Well Name: PLOW BOY FED	Well Location: T19S / R38E / SEC 35 / NWSE / 32.6156755 / -103.1182483	County or Parish/State: LEA / NM
Well Number: 01	Type of Well: OIL WELL	Allottee or Tribe Name:
Lease Number: NMNM14812	Unit or CA Name:	Unit or CA Number:
US Well Number: 3002536962	Operator: HILCORP ENERGY COMPANY

Sundry ID: 2842199

Type of Submission: Notice of Intent	Type of Action: Plug and Abandonment
Date Sundry Submitted: 03/18/2025	Time Sundry Submitted: 12:26
Date proposed operation will begin: 04/04/2025

## PLOW BOY #1

## P&amp;A WBD - Proposed Schematic

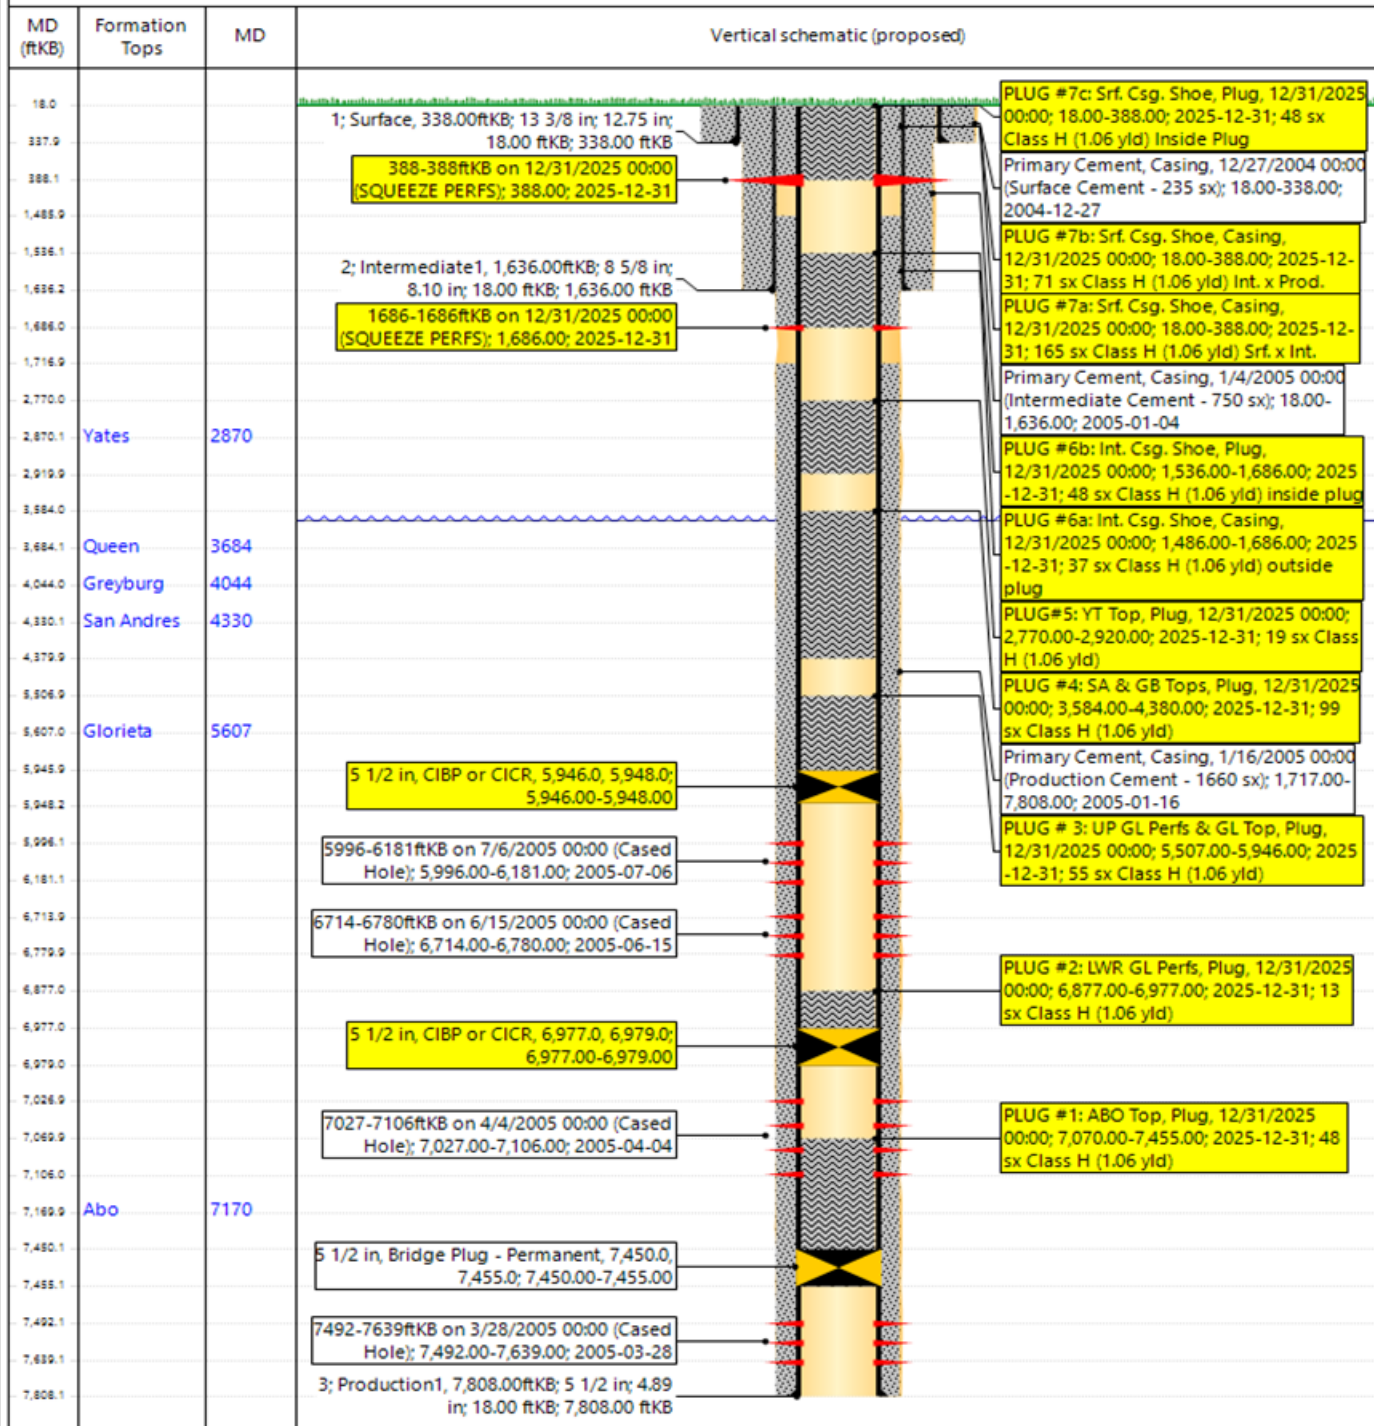
**REVISED**

6. PU & TIH w/ work string to **+/- 7,455'**.
7. **PLUG #1: 48sx of Class H Cement (16.4 PPG, 1.06 yield); ABO Top @ 7,170':**  
Pump a 48 sack balanced cement plug inside the 5-1/2" casing (est. **TOC @ +/- 7,070'** & est. **BOC @ +/- 7,455'**). Wait on Cement for **6** hours, tag TOC w/ work string. \*Note cement plug lengths & volumes account for excess. **Tag at min 7106'**.

8. POOH w/ work string. RIH and set a **5-1/2"** CIBP or CICR at **+/- 6,977'** to isolate Lower GL Perfs.
9. **PLUG #2: 25sx of Class H Cement (16.4 PPG, 1.06 yield); Lower GL Perfs @ 5,996':**  
Pump a 25 sack balanced cement plug inside the 5-1/2" casing (est. **TOC @ +/- 6,877'** & est. **BOC @ +/- 6,977'**). \*Note cement plug lengths & volumes account for excess. **Wait on Cement for 6 hours, tag TOC w/ work string. Tag at min 6780'**.

10. POOH w/ work string. RIH and set a **5-1/2"** CIBP or CICR at **+/- 5,946'** to isolate the Upper GL Perfs. Load the well as needed. Pressure test the casing above the plug to **500 psig for 30 minutes**.

14. PUH w/ work string to **+/- 2,946'**.
15. **PLUG #5: 36sx of Class H Cement (16.4 PPG, 1.06 yield); YT Top @ 2,870':**  
Pump a 36 sack balanced cement plug inside the 5-1/2" casing (est. **TOC @ +/- 2,770'** & est. **BOC @ +/- 2,920'**). \*Note cement plug lengths & volumes account for excess. **Wait on Cement for 6 hours, tag TOC w/ work string. Tag at min 2654'**.

16. TOOH w/ work string. TIH & perforate squeeze holes @ **+/- 1717'**. Establish circulation. TIH with tubing/work string to **+/- 1667'**.
17. **PLUG #6: 85sx of Class H Cement (16.4 PPG, 1.06 yield); Int. Casing Shoe @ 1,636':**  
Pump **48sx** of cement in the 5-1/2" casing X 7-7/8" open hole annulus (est. **TOC @ +/- 1,636'** & est. **BOC @ +/- 1,686'**). Pump a **27 sack** balanced cement plug inside the casing (est. **TOC @ +/- 1,536'** & est. **BOC @ +/- 1,686'**). WOC for 4 hrs, tag TOC w/ work string. \*Note cement plug lengths and volumes account for excess. **Tag at min 1504'**.

18. TOOH w/ work string. TIH & perforate squeeze holes @ **+/- 388'**. Establish circulation.
19. **PLUG #7: 119sx of Class H Cement (16.4 PPG, 1.06 yield); Surf. Casing Shoe @ 338':**  
Pump **71sx** of cement in the 5-1/2" casing X 8-5/8" casing annulus (est. **TOC @ +/- 0'** & est. **BOC @ +/- 388'**). Pump a 48 sack balanced cement plug inside the 5-1/2" casing (est. **TOC @ +/- 0'** & est. **BOC @ +/- 388'**). WOC for 4 hrs, tag TOC w/ work string. \*Note cement plug lengths and volumes account for excess.

Plug Type	Top	Bottom	Length	Tag	Sacks	Cement Class	Notes
Surface Plug	0.00	100.00	100.00	Tag/Verify			
13.375 inch- Shoe Plug	284.62	388.00	103.38	Tag/Verify	119.00	H	Perf and squeeze from 388' to surface.

8.625 inch- Shoe Plug	1569.64	1686.00	116.36	Tag/Verify			
Top of Salt @ 1732	1664.68	1782.00	117.32	Tag/Verify	65.00	H	Perf and squeeze from 1717' to 1504'. WOC and Tag. (In 27 sxs/Out 38 sxs)
Base of Salt @ 2732	2654.68	2782.00	127.32	Tag/Verify			
Yates @ 2896	2817.04	2946.00	128.96	If solid base no need to Tag (CIBP present and/or Mechanical Integrity Test), If Perf & Sqz then Tag, Leak Test all CIBP if no Open Perforations	36.00	H	Spot cement from 2946' to 2654'. WOC and Tag.
Queen @ 3684	3597.16	3734.00	136.84	base no			
San Andres @ 4330	4236.70	4380.00	143.30	If solid base no need to Tag (CIBP present and/or Mechanical Integrity Test), If Perf & Sqz then Tag, Leak Test all CIBP if no Open Perforations	99.00	H	Spot cement from 4380' to 3597'. WOC and Tag.
Glorieta @ 5624	5517.76	5674.00	156.24	base no

If solid base no need to Tag (CIBP present and/or Mechanic al Integrity Test), If Perf & Sqz then Tag, Leak Test all CIBP if no Open Perforatio ns			
<b>CIBP Plug</b>	5911.00	5946.00	35.00		55.00	H	Set CIBP at 5946'. Leak Test CIBP. Spot cement from 5946' to 5517'. WOC and Tag.
<b>Perforations Plug (If No CIBP)</b>	5946.00	6231.00	285.00	Tag/Verify			
<b>Perforations Plug (If No CIBP)</b>	6662.20	6830.00	167.80	Tag/Verify			
				If solid base no need to Tag (CIBP present and/or Mechanic al Integrity Test), If Perf & Sqz then Tag, Leak Test all CIBP if no Open Perforatio ns			
<b>CIBP Plug</b>	6942.00	6977.00	35.00		25.00	H	Set CIBP at 6977'. Spot 25 sacks on top. WOC and Tag at 6780'.
<b>Perforations Plug (If No CIBP)</b>	6977.00	7156.00	179.00	Tag/Verify			
<b>ABO in Plateform Shelf @ 7170</b>	7048.30	7220.00	171.70	base no			
<b>5.5 inch- Shoe Plug</b>	7679.92	7858.00	178.08	Tag/Verify	43.00	H	Tag CIBP at 7455'. Spot cement from 7455' to 7106'.
